Twiggs Park Playground Improvements

Bid # 25-34

ADDENDUM No. 1

June 27, 2025

SHEET NO.
G-01

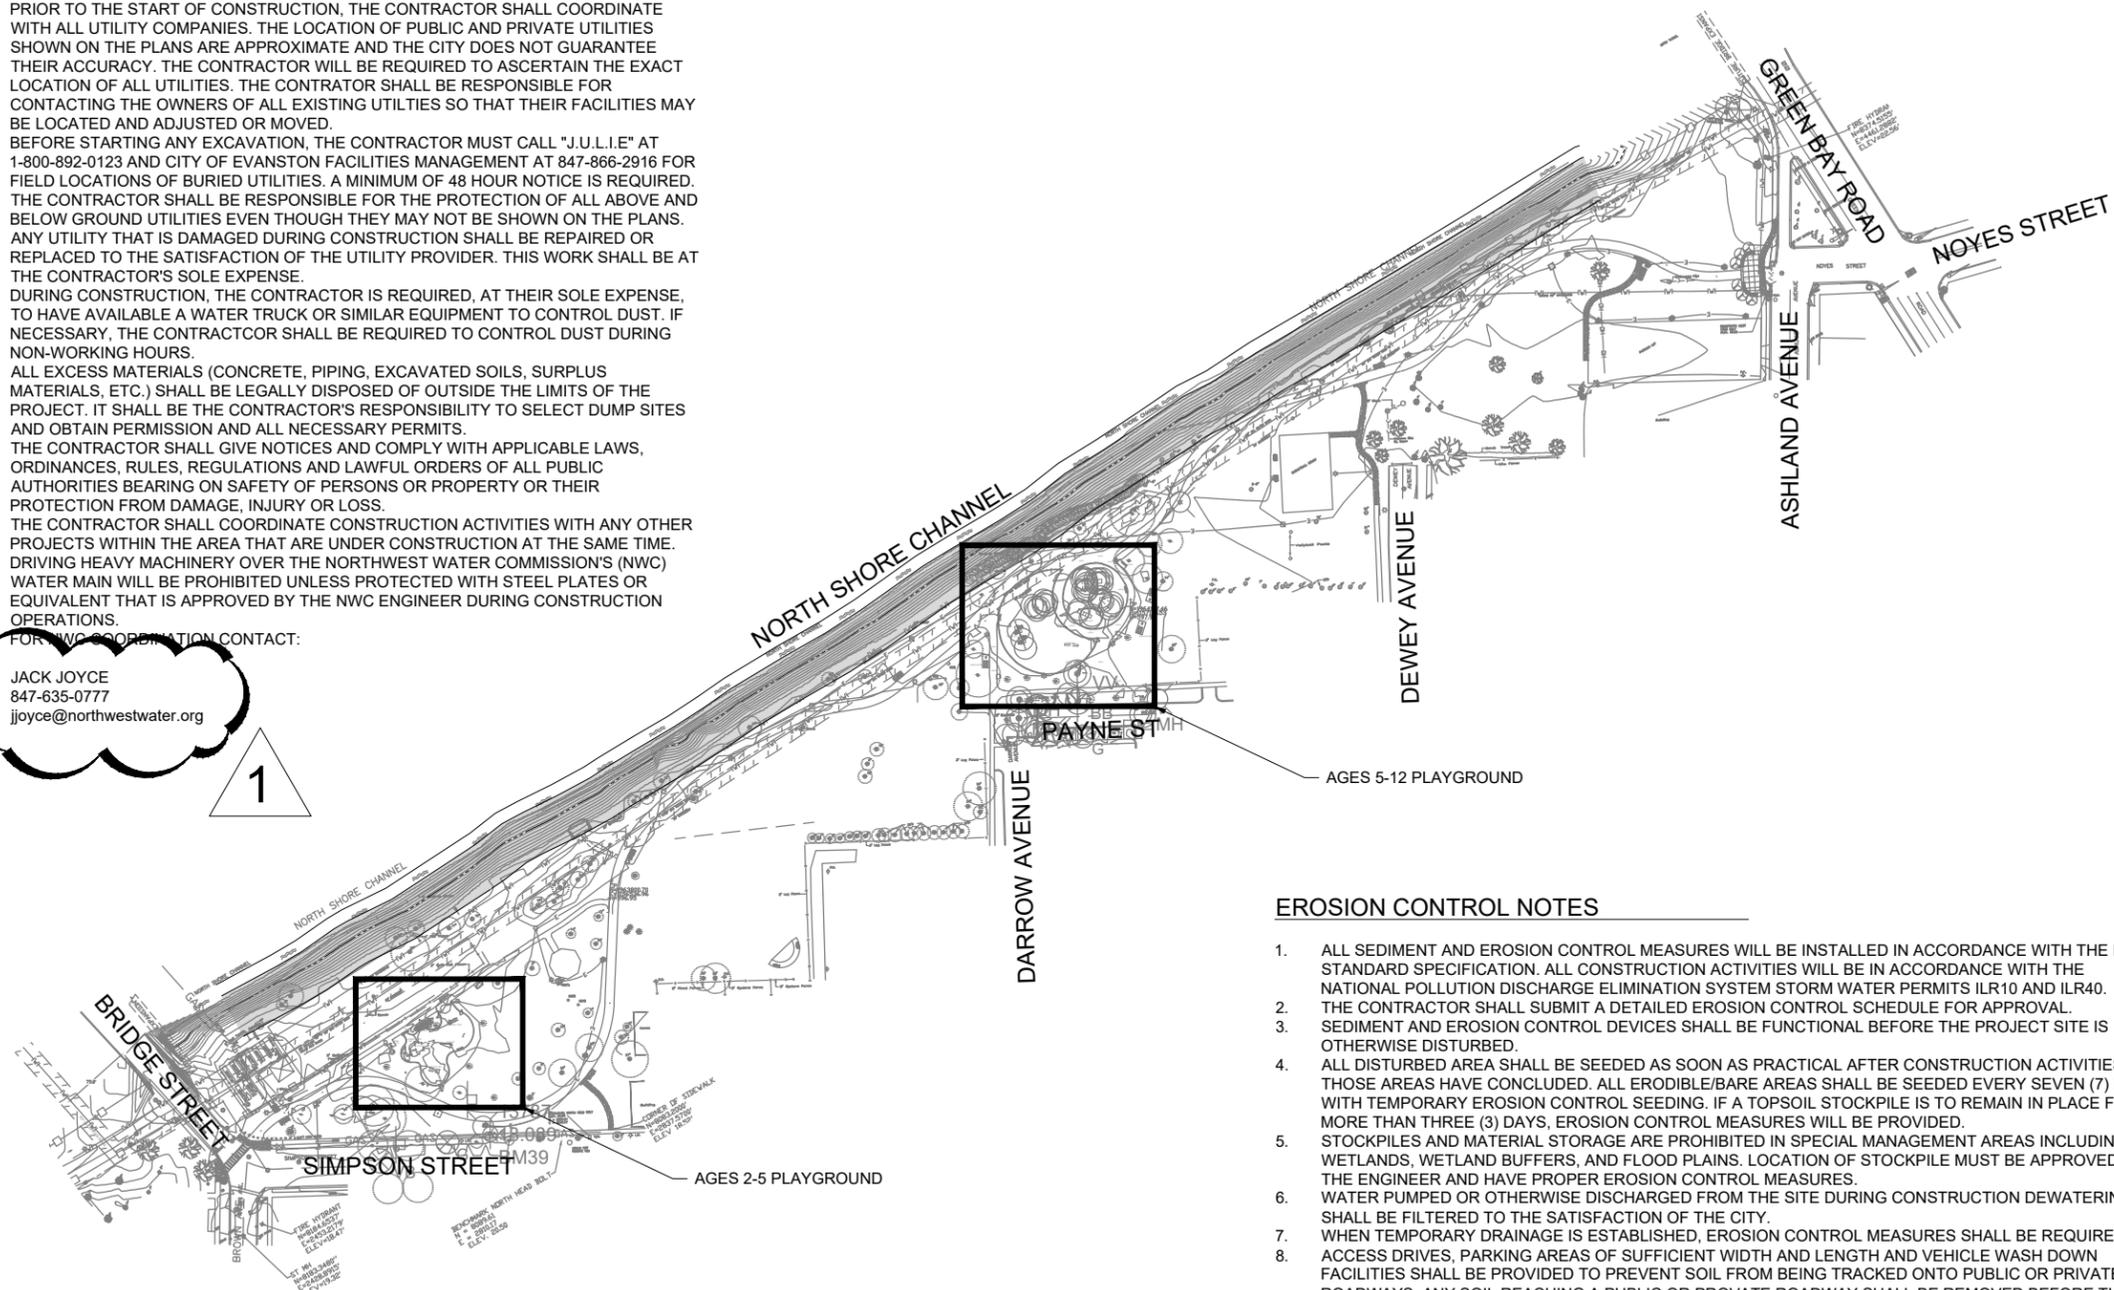
Sheet G-01

- NWC Contact information update

9. FOR NWC COORDINATION CONTACT:

JACK JOYCE
847-635-0777
jjoyce@northwestwater.org

E COAL RECEPTACLE NOT TO SCALE

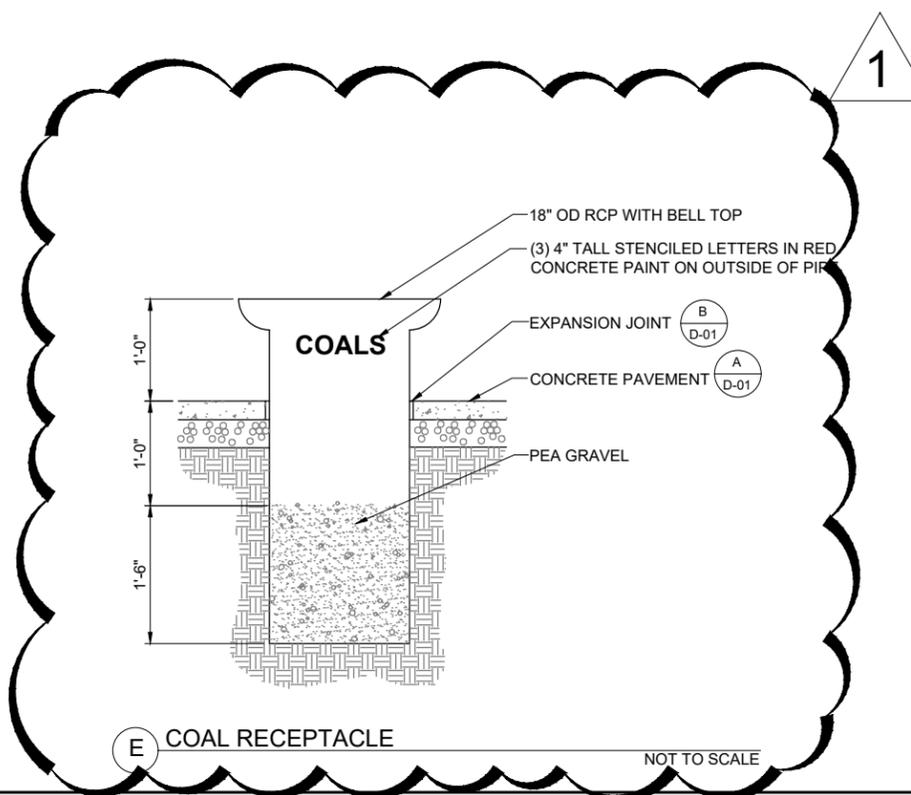
Sheet D-02

- Addition of Detail E: Coal Receptacle
